Product Safety Recall

YAMAHA MT09/XSR900 Motorcycle Handlebar Exchange

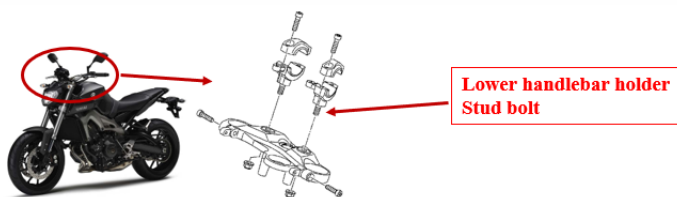
The lower handlebar holder may have been manufactured with improper paint application. Additionally, thread locking agent may not have been adequately applied to the stud bolt thread in the lower handlebar holder. Strong external impact may abrade the paint film causing axial force on the stud bolt.

With engine vibration, the stud may loosen and fall off resulting in loss of control.

Replacement of the handlebar clamp assembly.
